# JDC RANCH

A MASTER PLANNED COMMUNITY

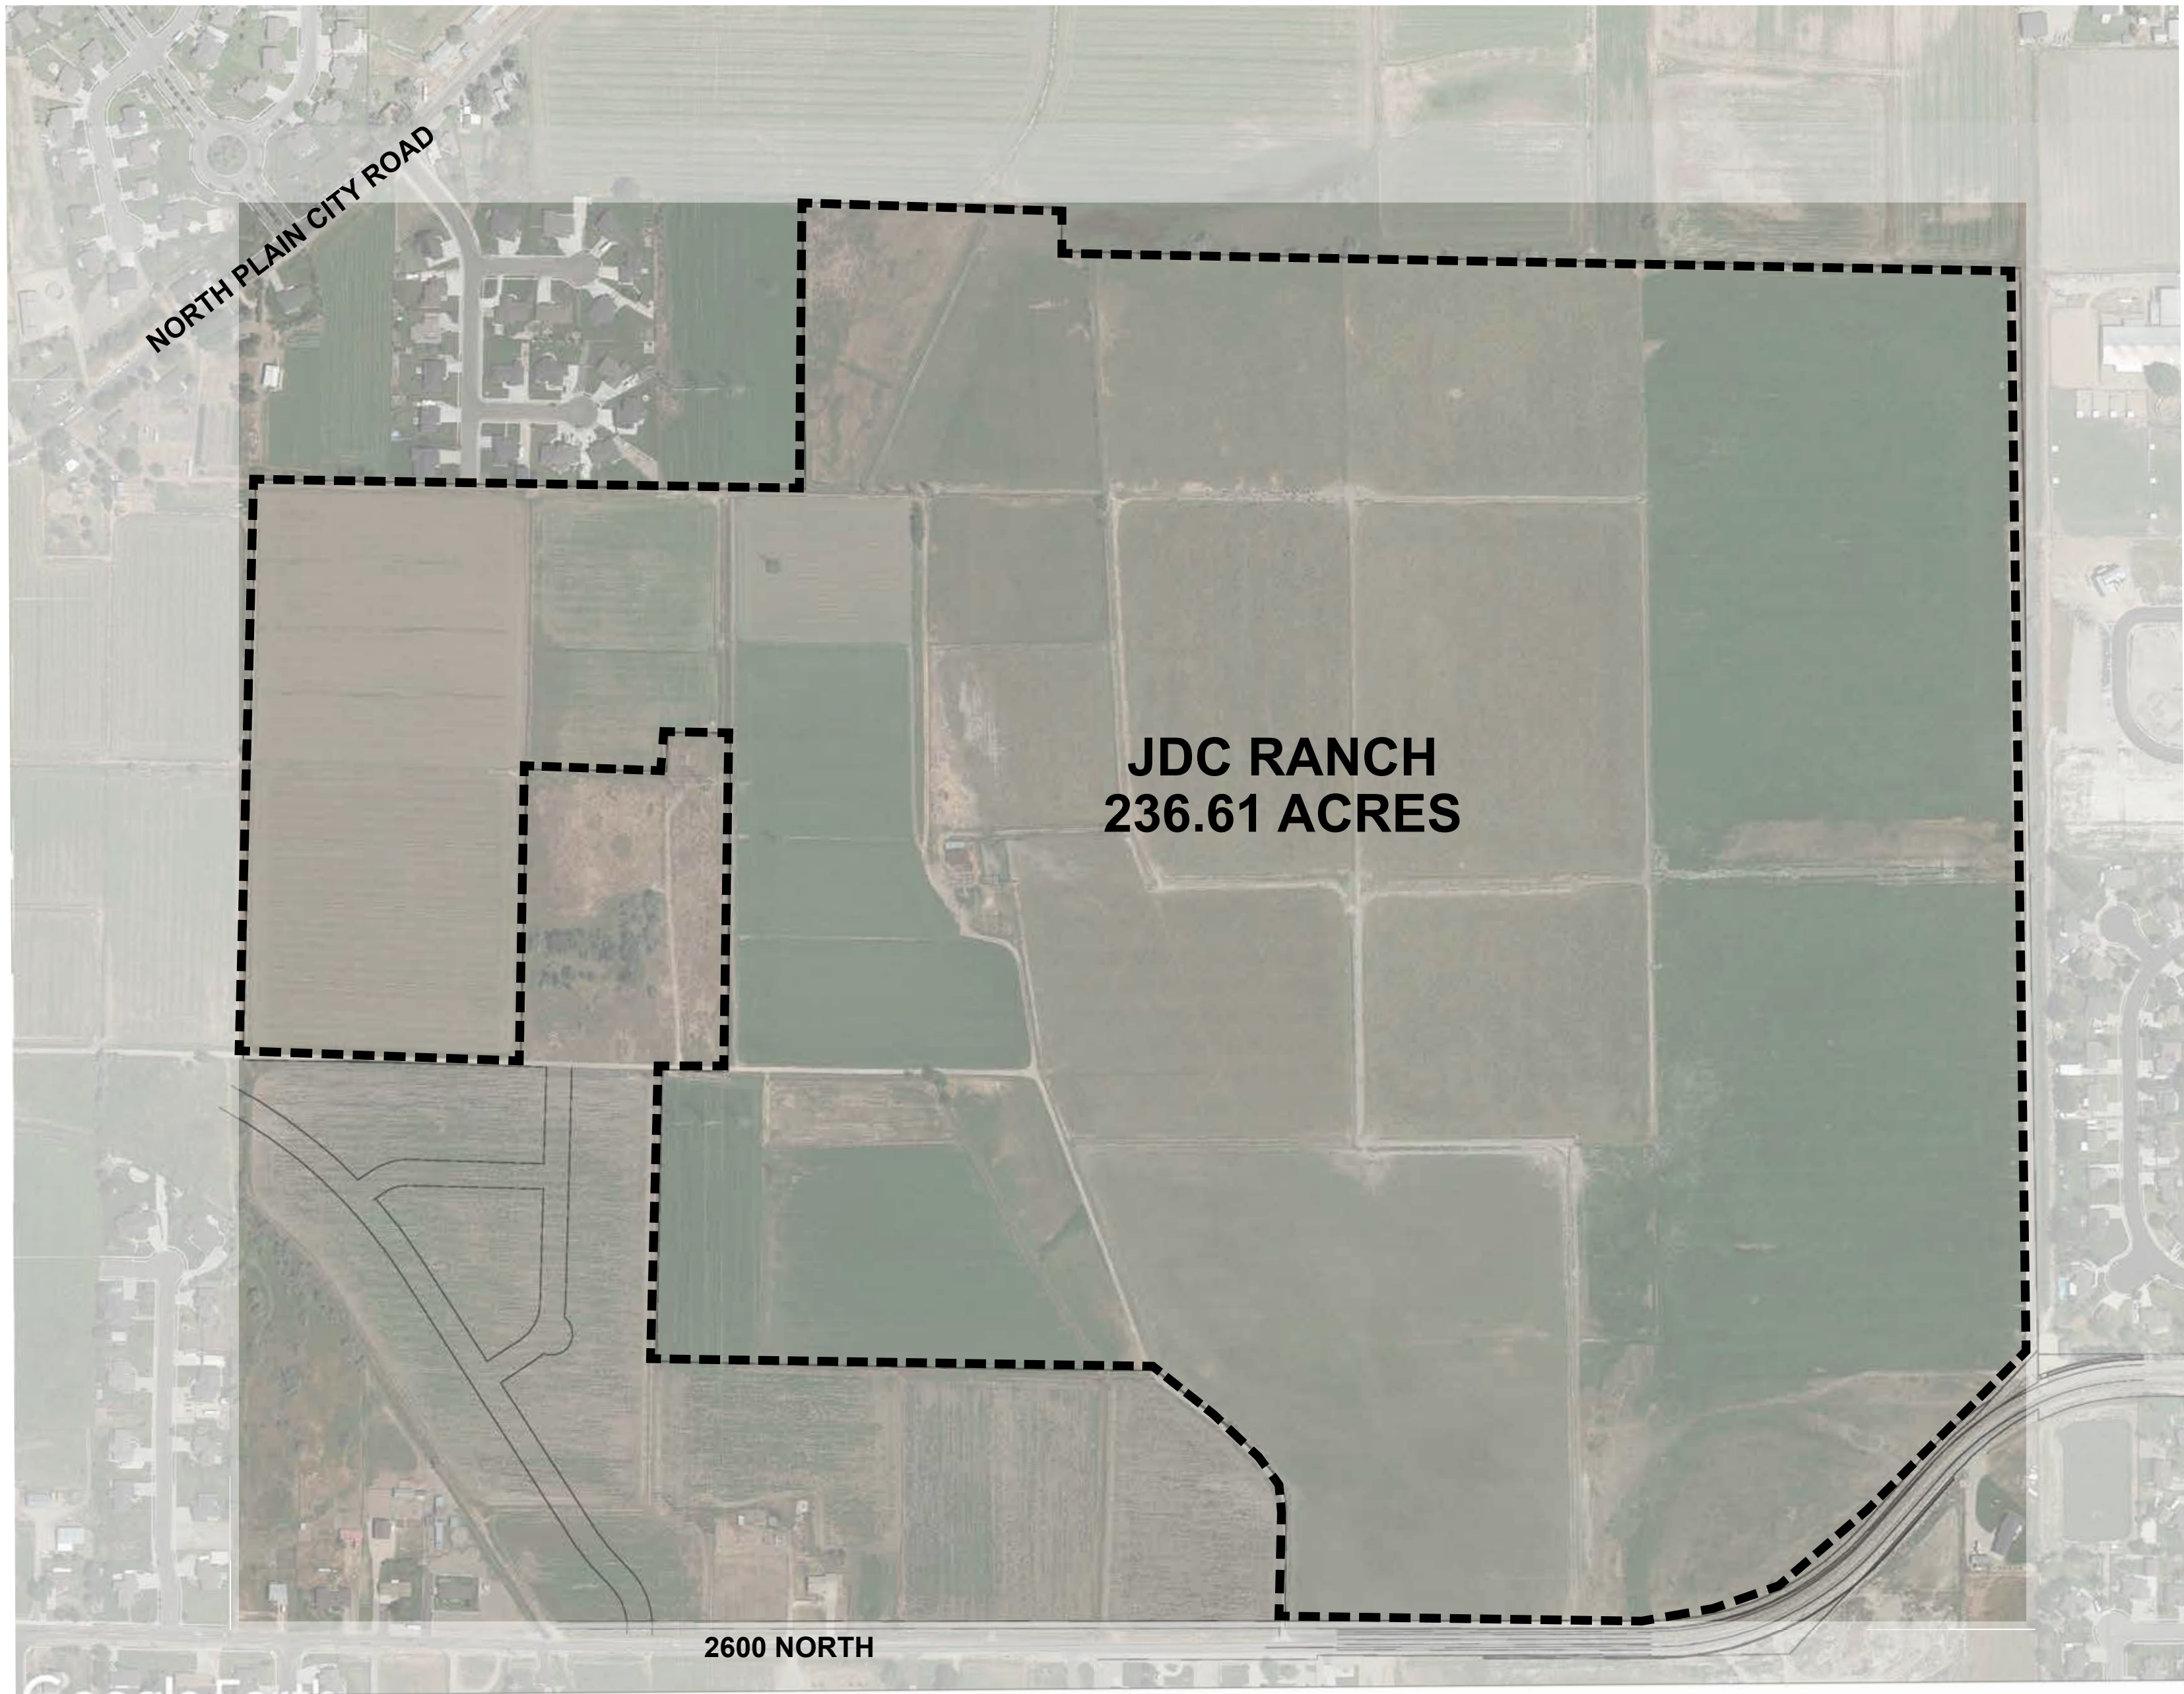
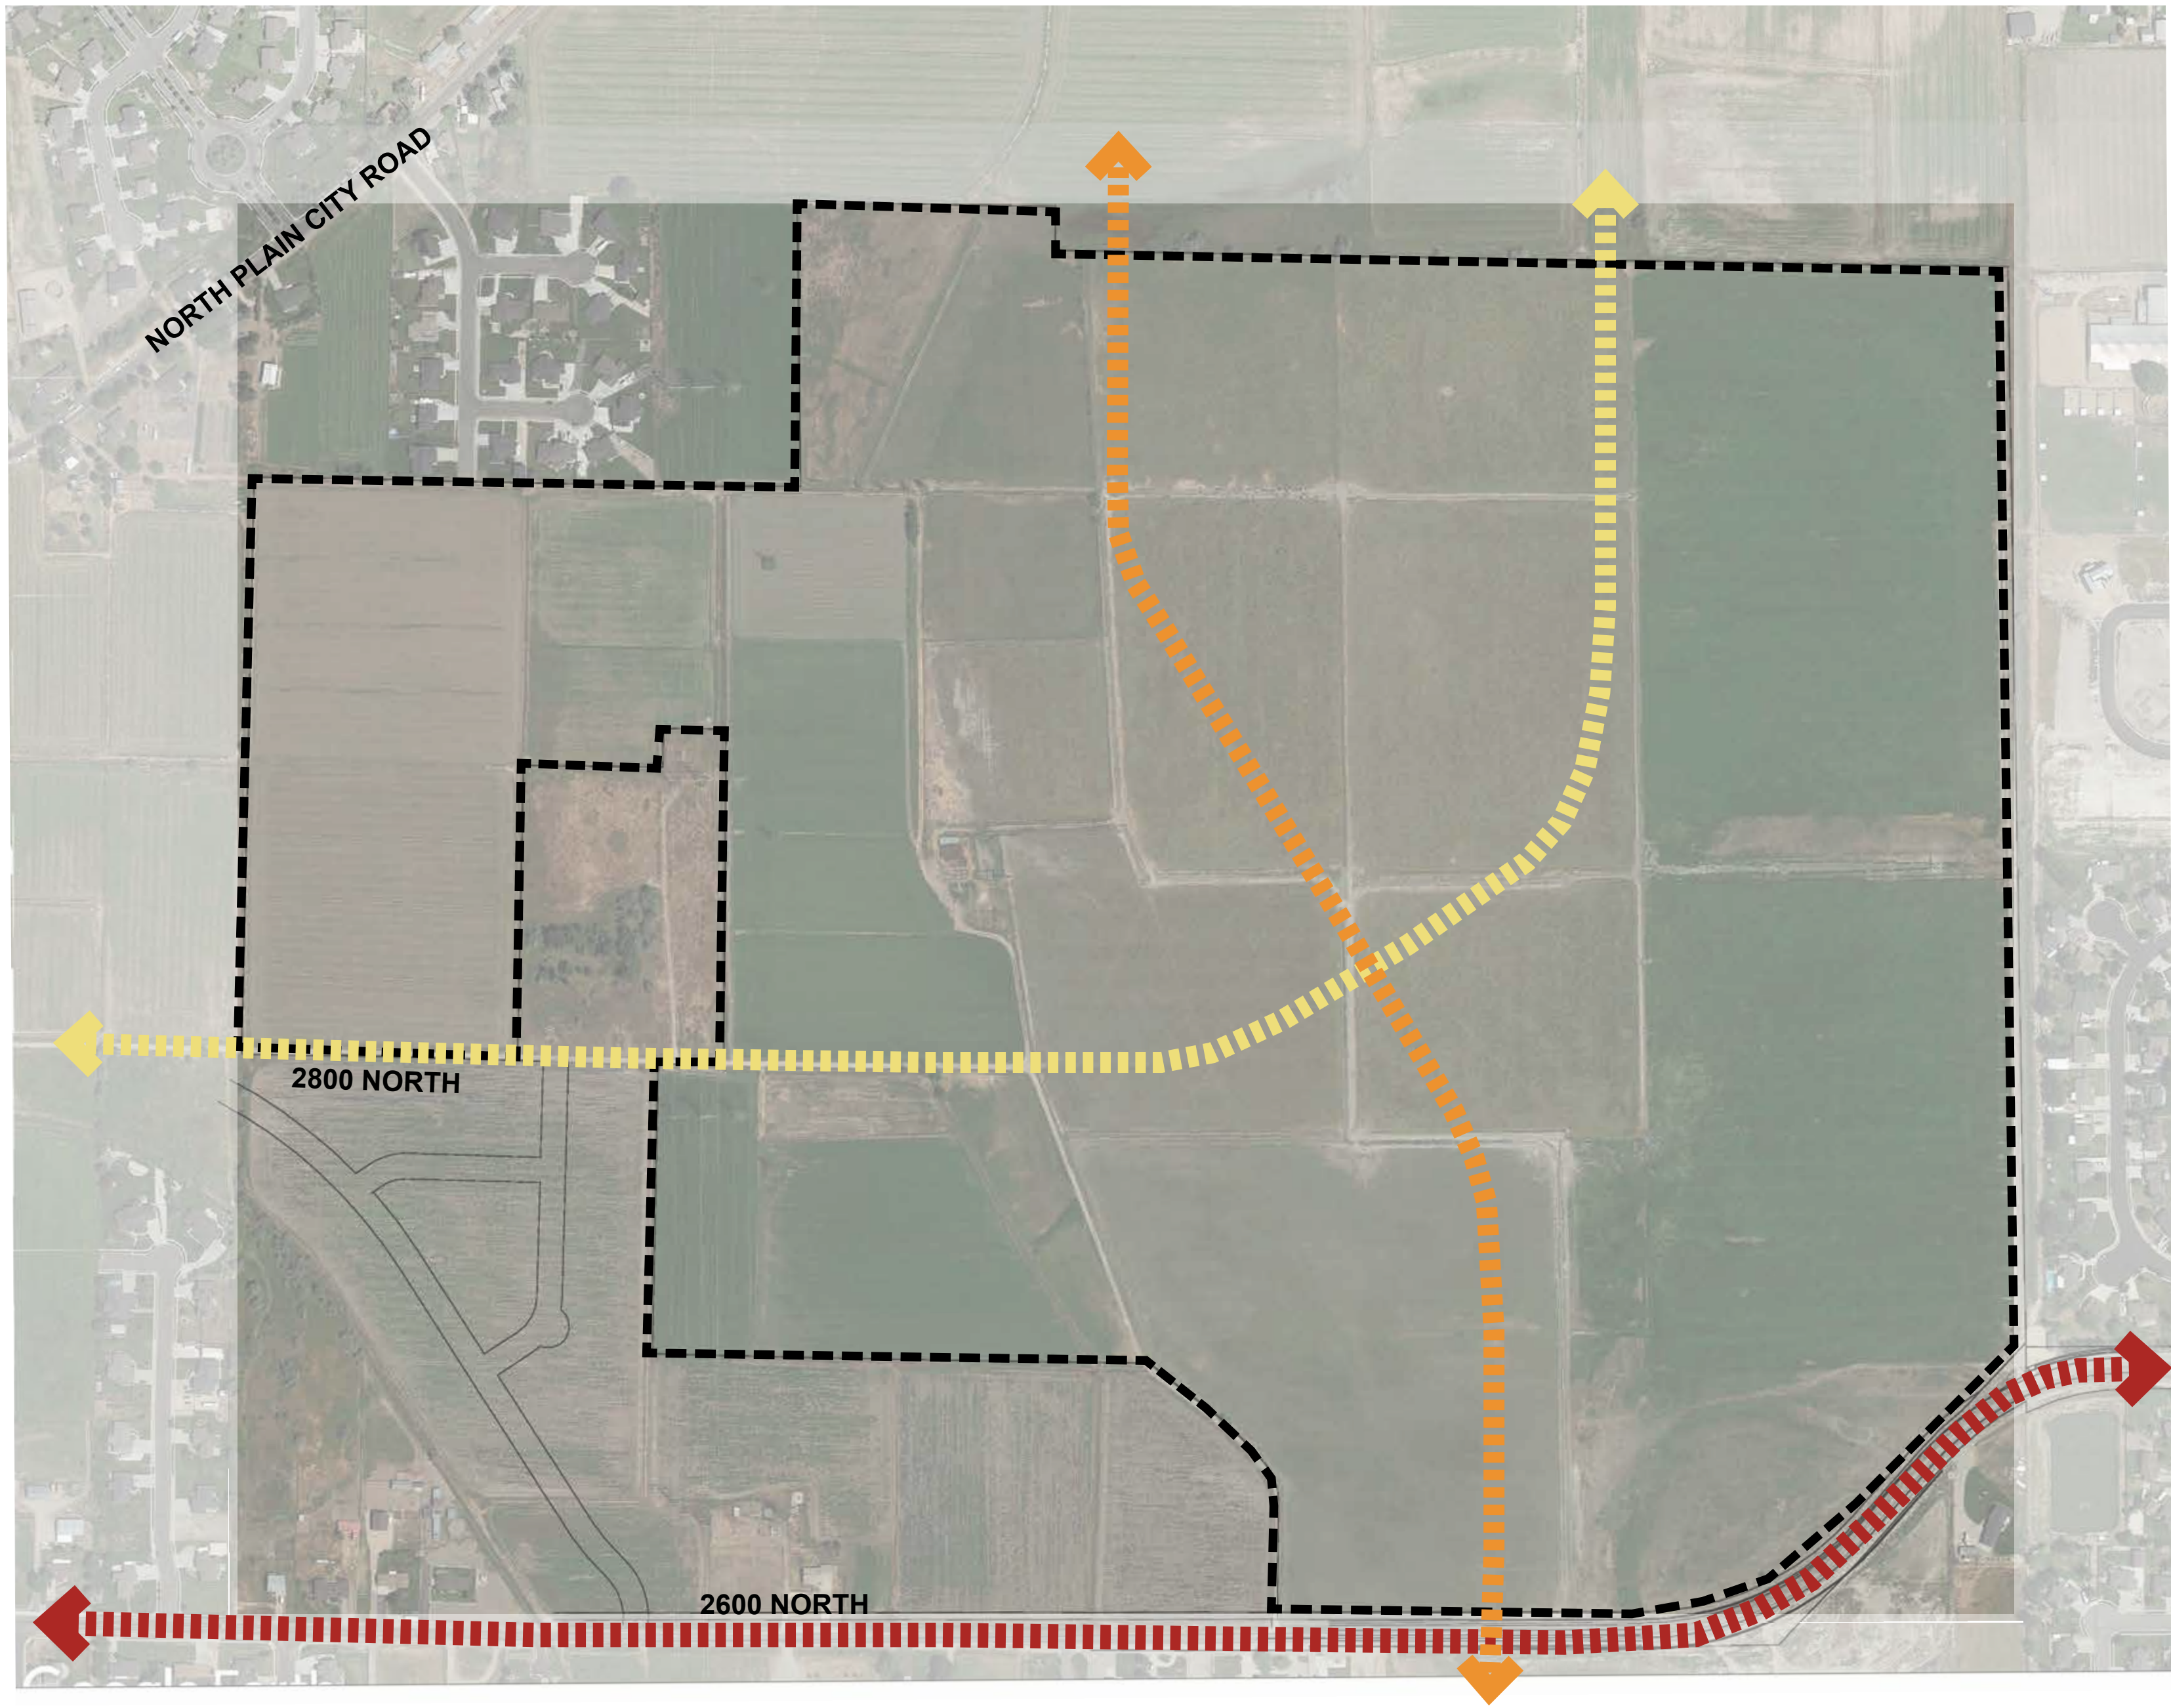
These streets need to be stubbed to adjacent land to the west and north.

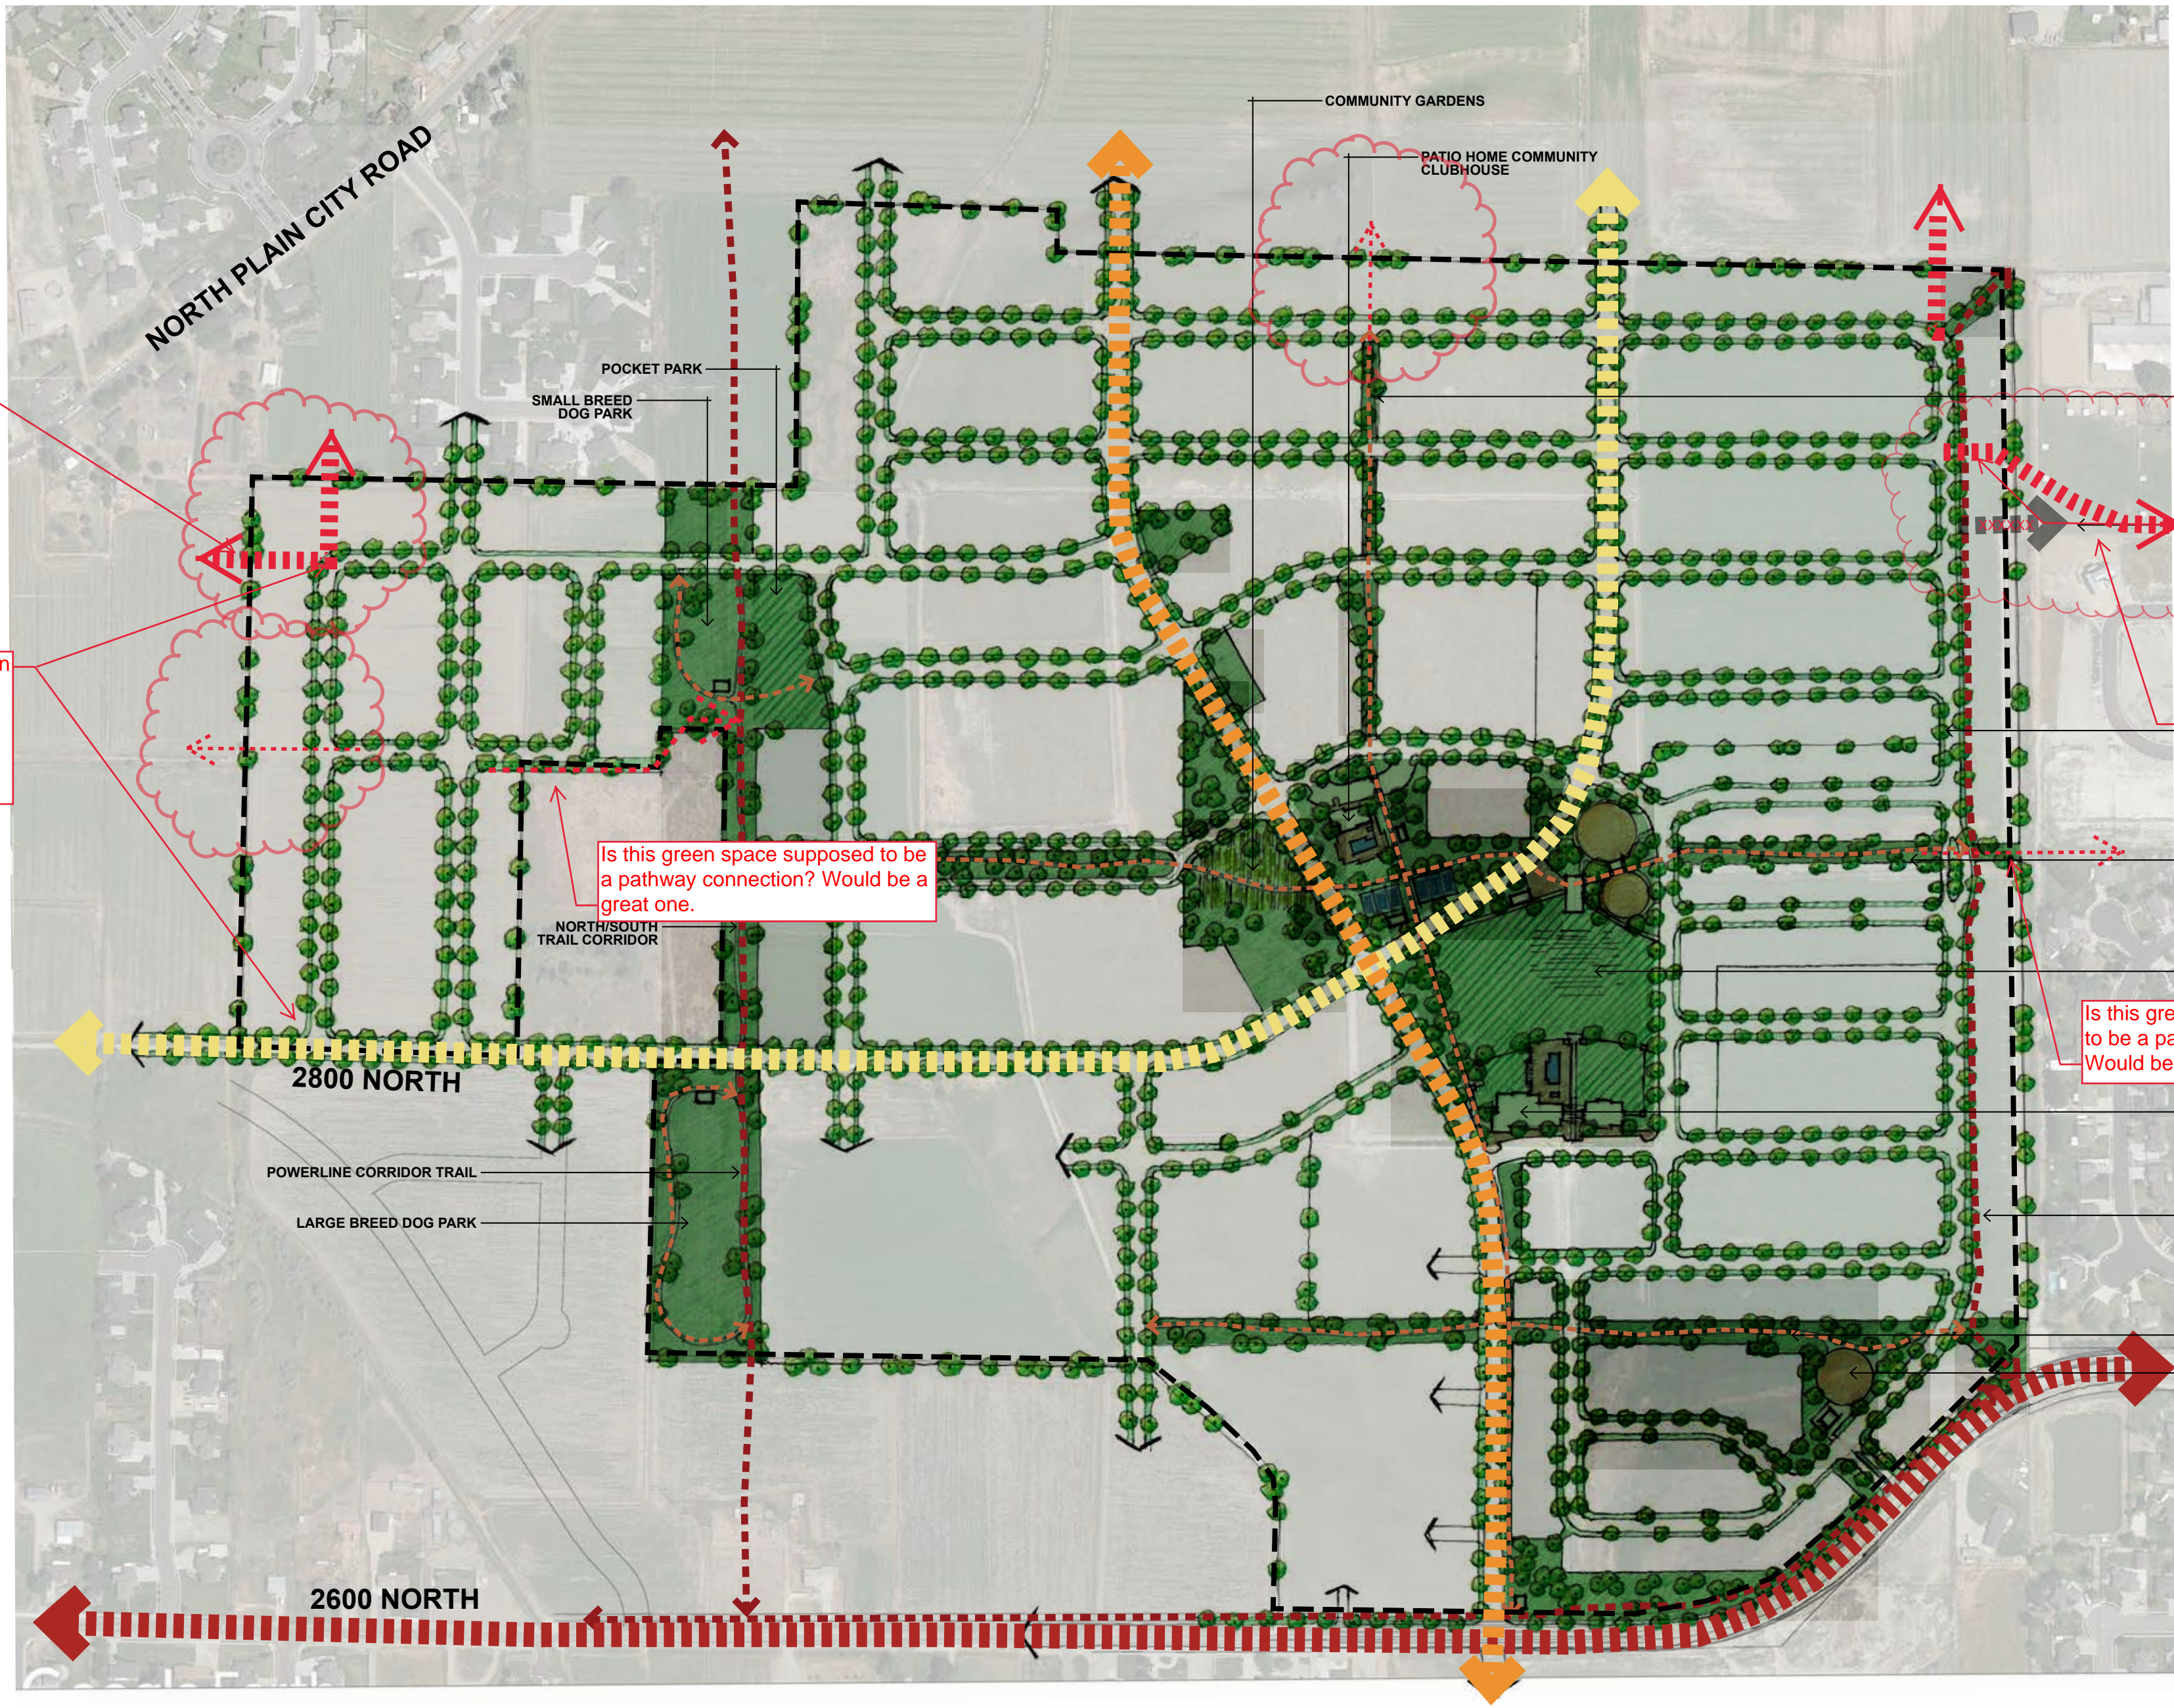
There appears to be more than 800 feet between these intersections. There either needs to be a street-stubbing to the adjacent land to the west or a mid-block pathway

Is this green space supposed to be a pathway connection? Would be a great one.

I would be more comfortable if this was a committed connection. If the adjacent land builds out without connecting then it can be abandoned.

Also, because the blocks in this plan are shallow, this street should connect to them at a 4-way intersection to avoid awkward 3-way jogs.

Is this green space supposed to be a pathway connection? Would be a great one.
